### APPEAL SUMMARY

**Appeal ID:** 19041

**Project Address:** 631 SE Taylor St

**Building/Business Name:** The Rose Apartments

GA5

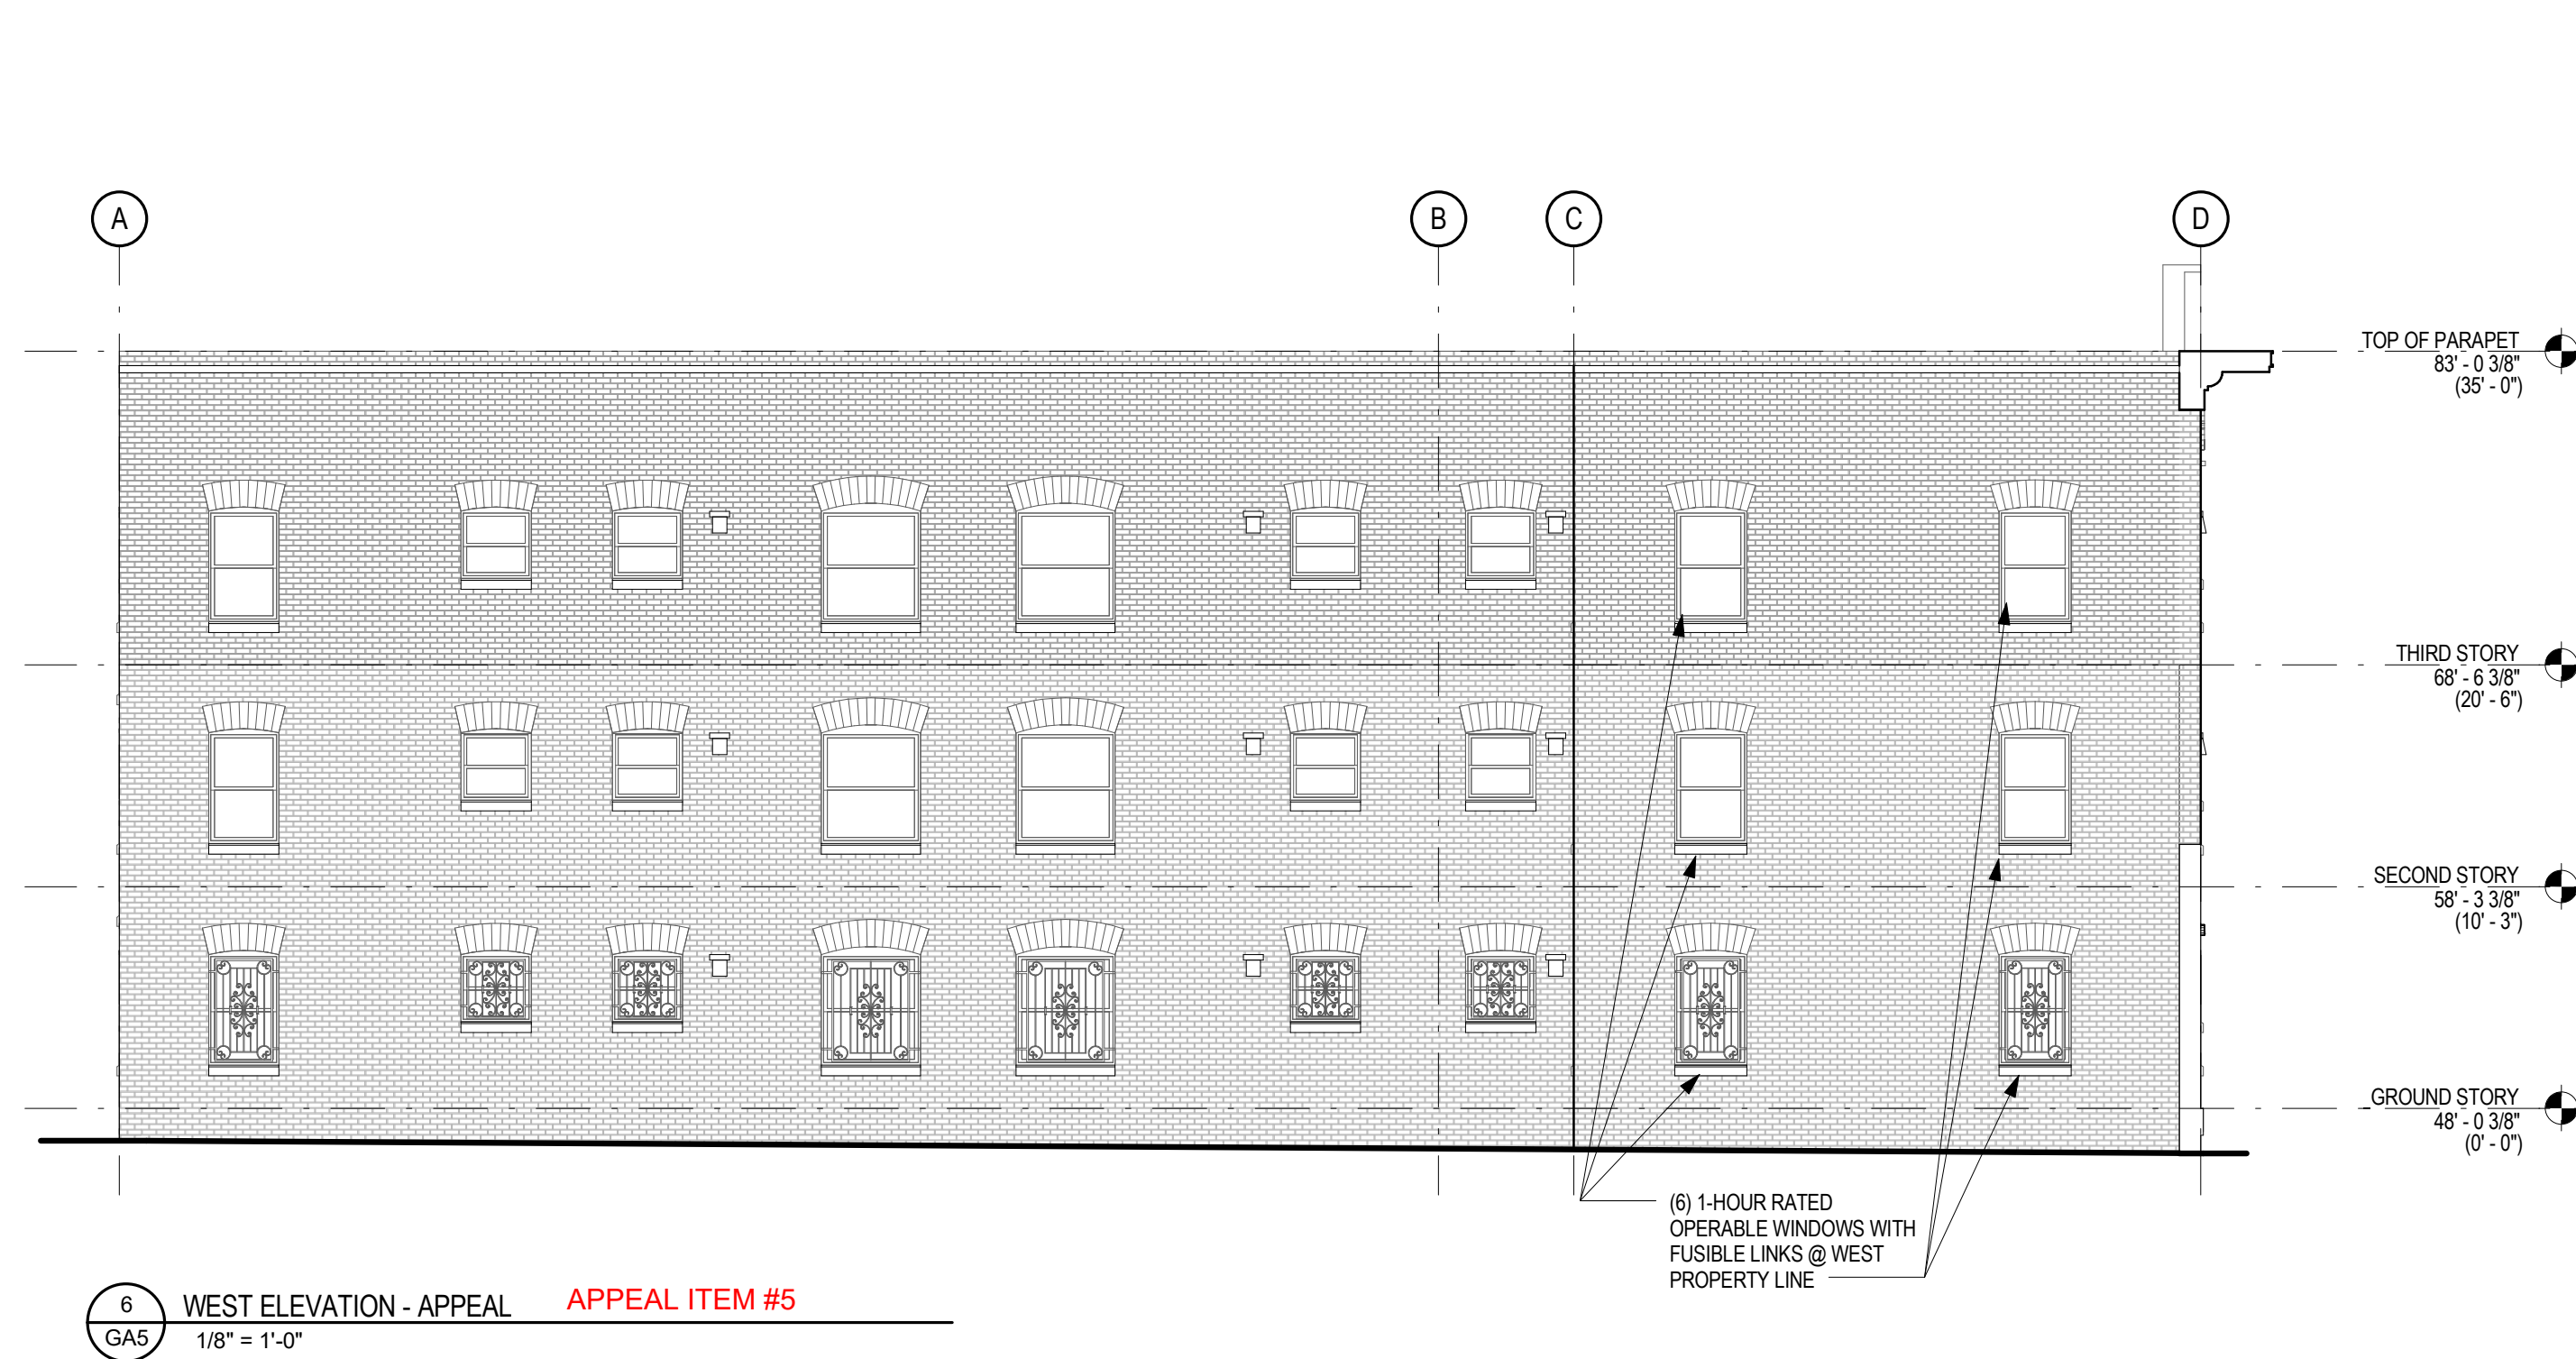
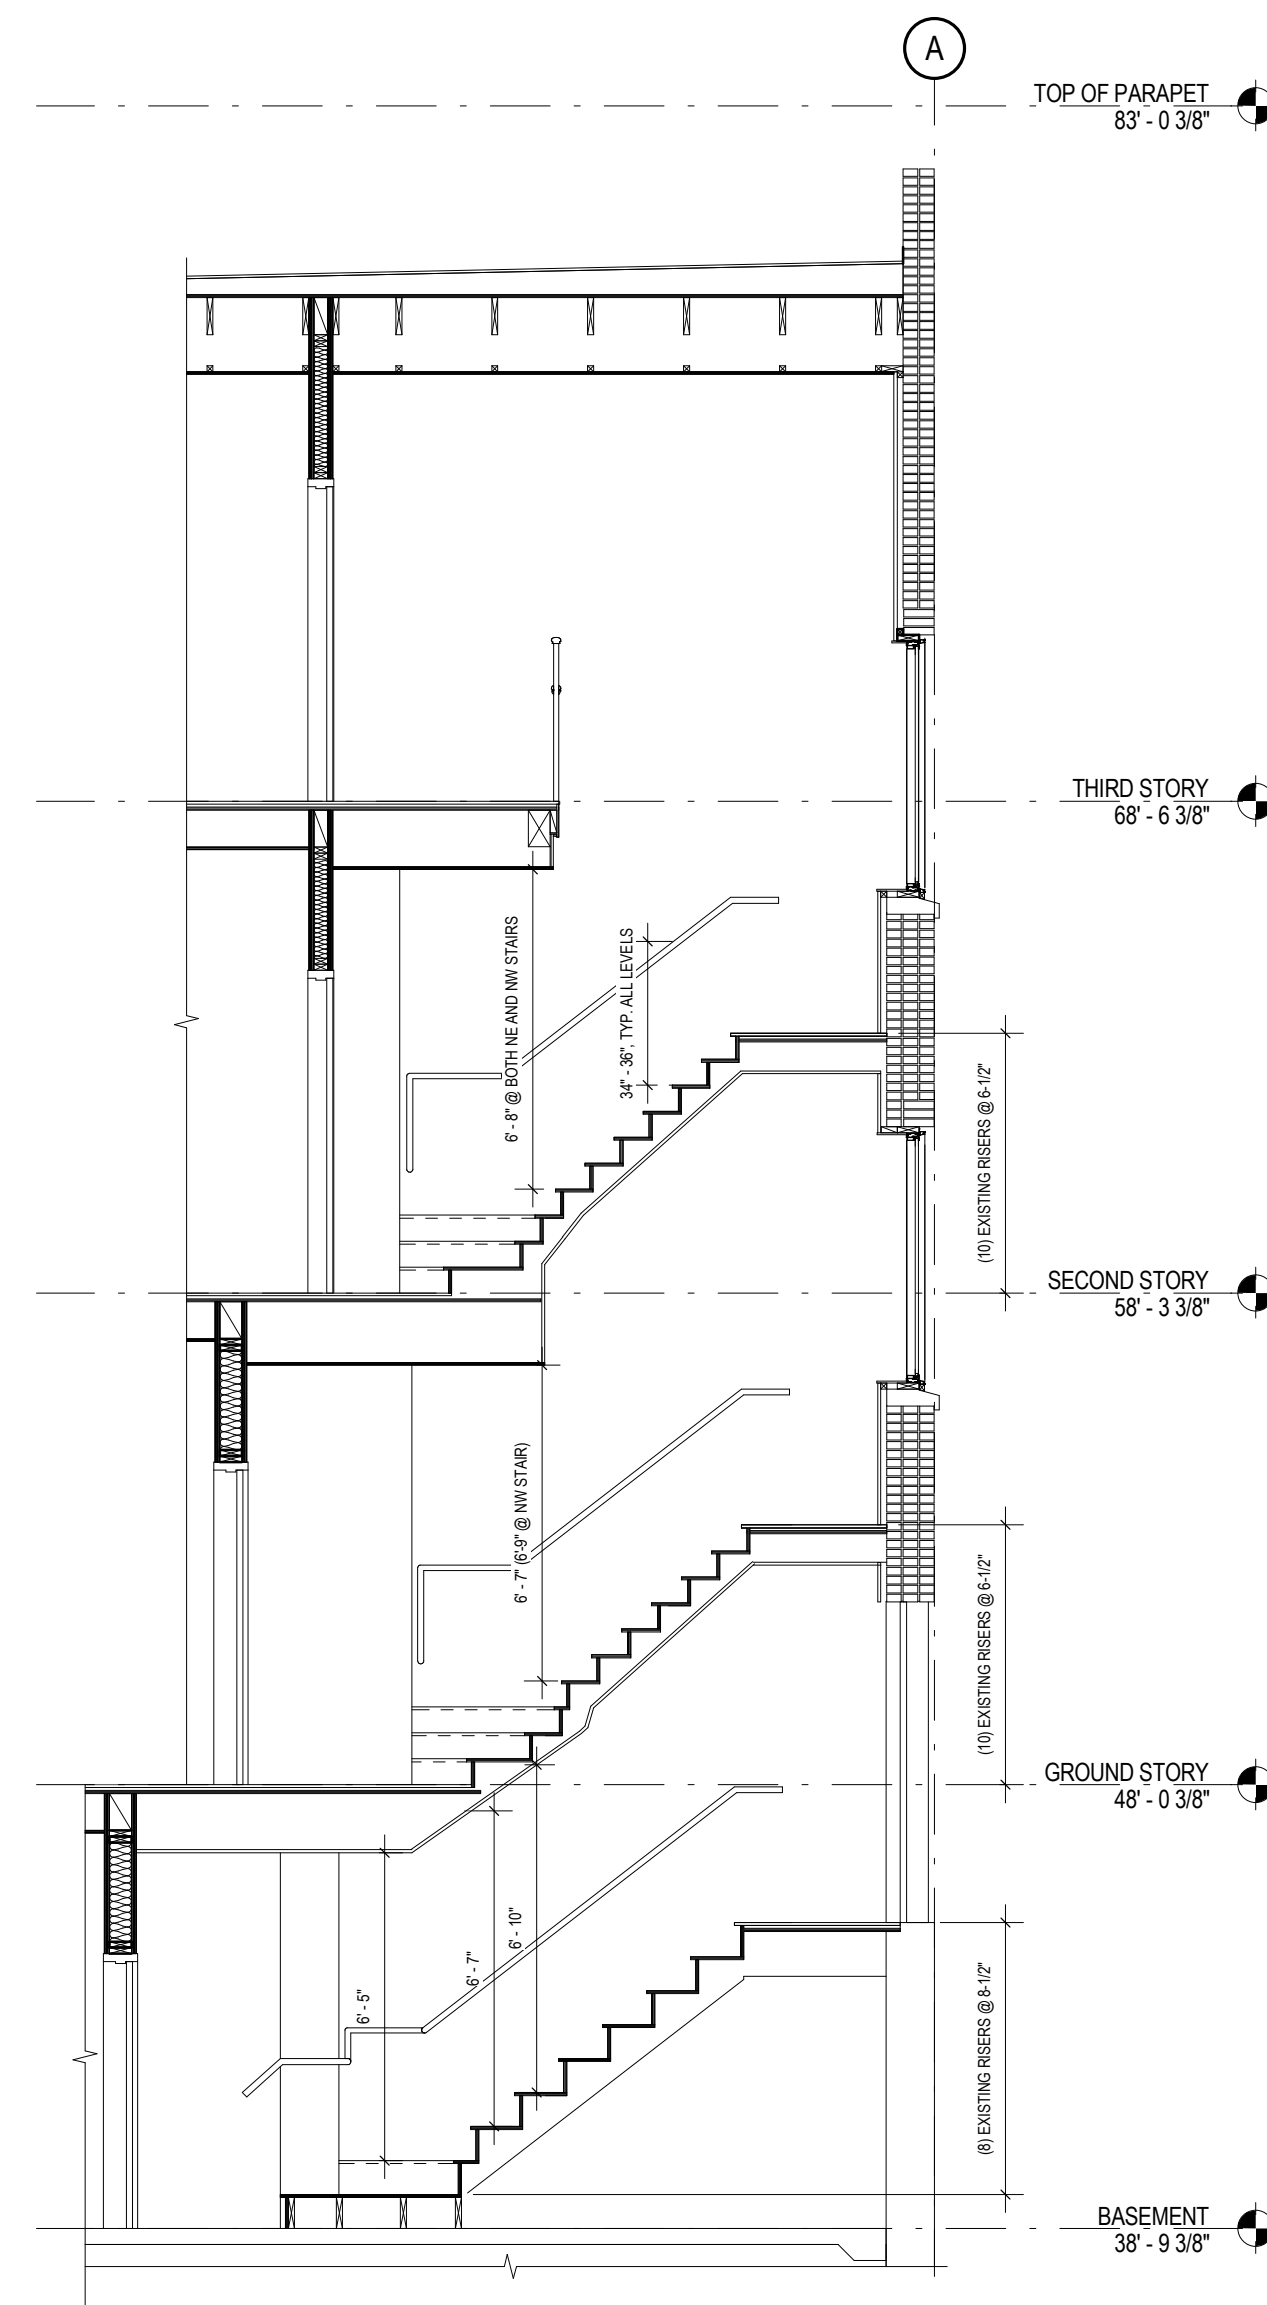
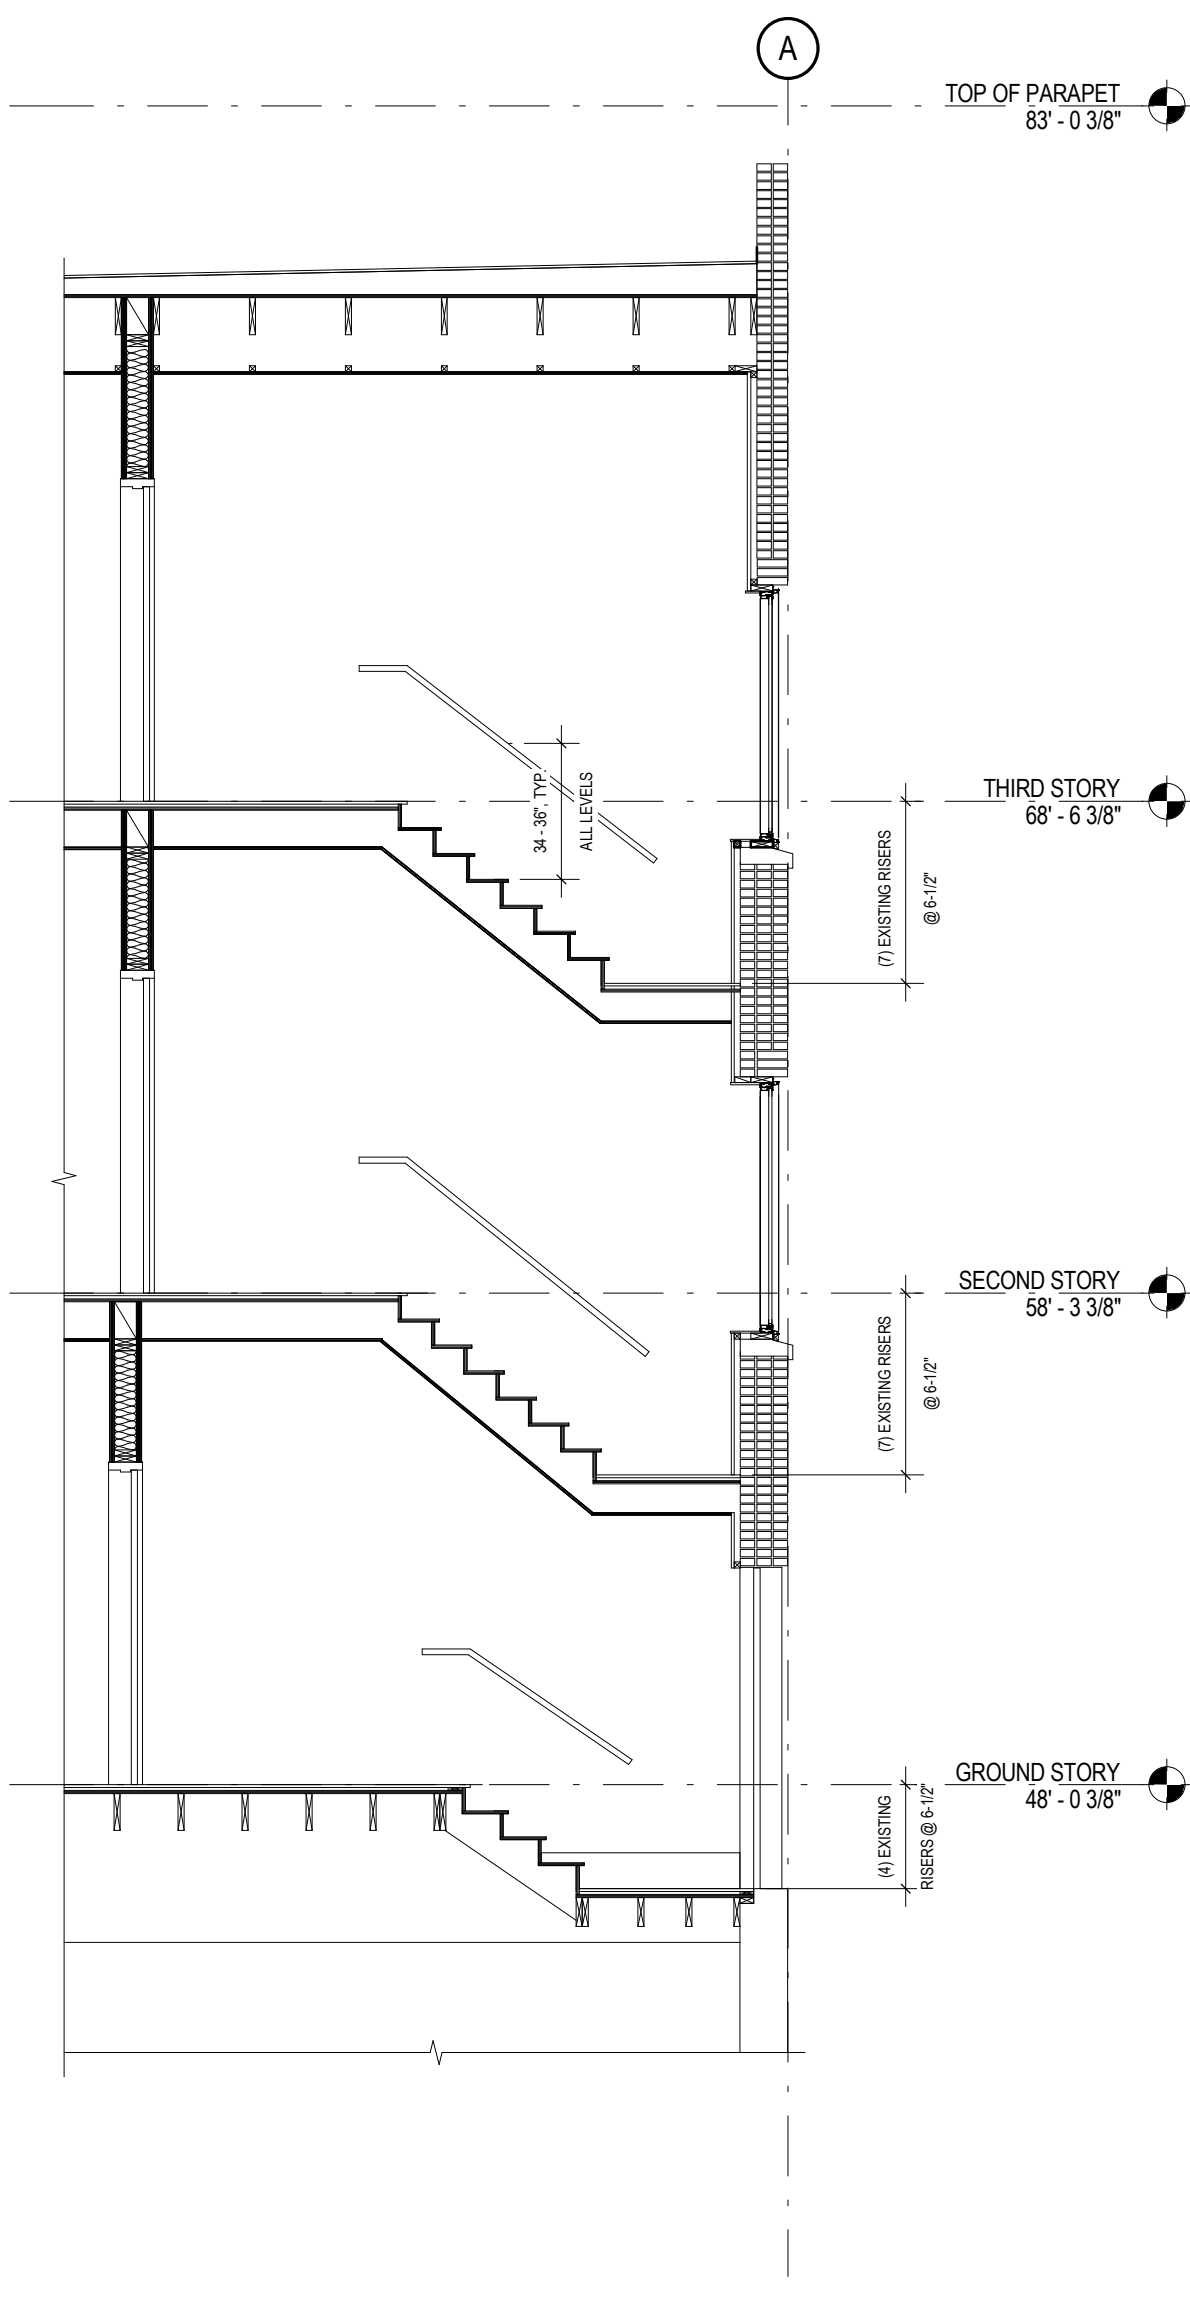
See Details 2, 3, 5 and 8/GA4, and Details 1, 2, 3 and 5/GA5.

<b>Code Section</b>	1012.6 Handrail Extensions
<b>Requires</b>	Where handrails are not continuous between flights, the handrails shall extend horizontally at least 12 inches beyond the top riser and continue to slope for the depth of one tread beyond the bottom riser.
<b>Proposed Design</b>	<p>ORIGINAL APPEAL TEXT: Within the existing northeast and northwest exit stairs, compliant top and bottom rail extensions will be provided where the plan configuration allows. Where there is not room for extensions due to existing conditions and space constraints, extensions will not be provided. See Details 2, 3, 5 and 8/GA4 for more detailed information.</p> <p>RECONSIDERATION TEXT: Within the existing northeast and northwest exit stairs, compliant top and bottom rail extensions will be provided where the plan configuration allows. Handrails will wrap the wall at winder tread locations. Where there is not room for extensions due to existing conditions and space constraints, extensions will be provided to the maximum length possible. See Details 2, 3, 5 and 8/GA4 and 1, 2, 3, 4 and 5/GA5 for more detailed information.</p>

<b>Code Section</b>	Table 705.8 Allowable Openings Based on Fire Separation Distance
<b>Requires</b>	Unprotected openings less than 3' from a property line are not permitted.
<b>Proposed Design</b>	<p>ORIGINAL APPEAL TEXT: The six unprotected operable windows at the west property line shall remain. The building shall be equipped with a full NFPA 13 sprinkler system throughout. See GA2 and GA3.</p> <p>RECONSIDERATION TEXT: The six unprotected operable windows at the west property line shall be replaced with UL listed 1-hour fire-rated operable windows with a fusible links that close the windows in the event of a fire. The building shall be equipped with a full NFPA 13 sprinkler system throughout. See GA2, GA3 and GA5.</p>

**2. Winder treads in 2 egress stairs: Granted as proposed.**

**3. Omission of handrail extensions in 2 egress stairs: Granted as proposed.**

**4. Proposed UL listed 1 hour fire rated operable windows with self closing mechanisms at property line: Granted as proposed.**
